INLAND WETLANDS & WATERCOURSES COMMISSION

MEMORANDUM

Re: IWWC#A21-3.3 / 475 Williams Road – Scott & Sandy Cavallaro – (in-ground pool, low wall, patio-surround & compensatory flood storage area/rain garden)

Re: IWWC #A21-4.2 / 4A Research Parkway – Six Research, LLC – (industrial development - automotive storage)

475 Williams Rd
Photo 4/27/21

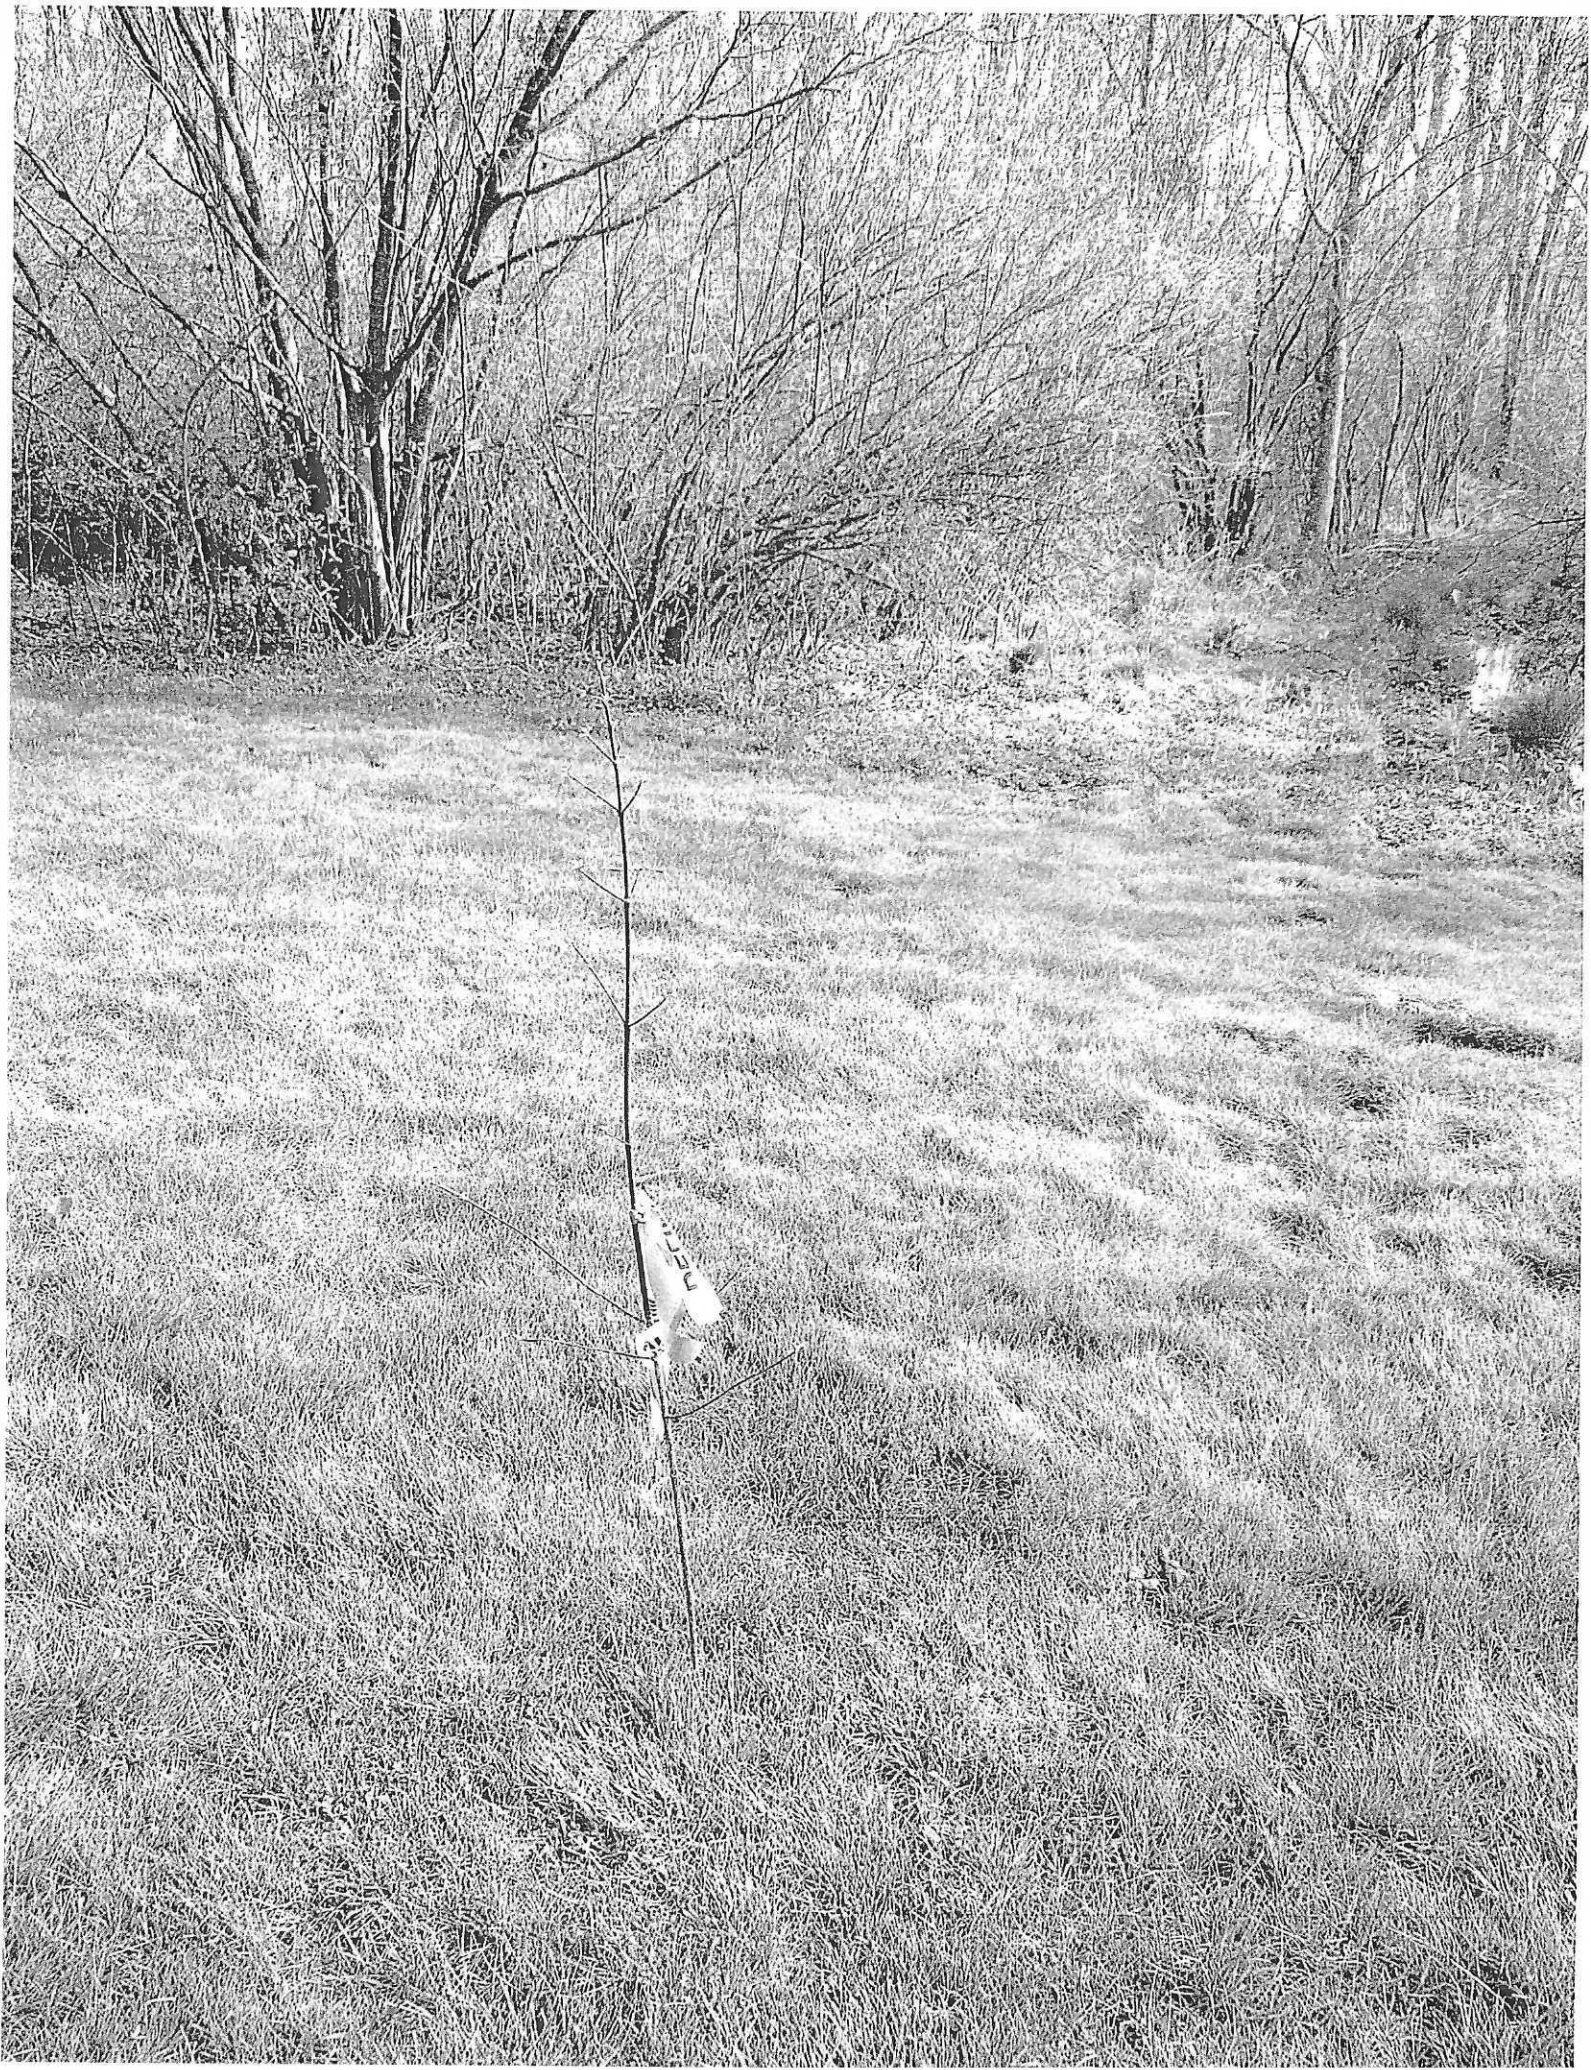
Site alterations in the vicinity of Wetland Flag #18 are particularly problematic. As can be seen in the recent photos, a branch in the lawn (erected by Mr. Lord) is Wetland Flag #18 and it is surrounded by lawn sod. Sod has been recently installed without permitting in the wetlands here (and in URA) and the sod area extends in the wetlands south of Wetland Flag #18 about 30 feet to the swamp woods/shrub line. At this writing no “Wetlands Report” has been submitted so it is unknown what type of wetland soil was found here or even if Mr. Lord encountered sod here when he mapped in 12/2020. This flag is located 12 feet south of the proposed low wall around the proposed pool (which is 20 feet away from the flag) and a silt fence is proposed right at the flag. This office proposes this area should be restored at minimum to the wetland boundary. It may be possible to relocate the pool area further to the east (and turned sideways) - as suggested above – thus providing a greater distance to the actual wetlands.
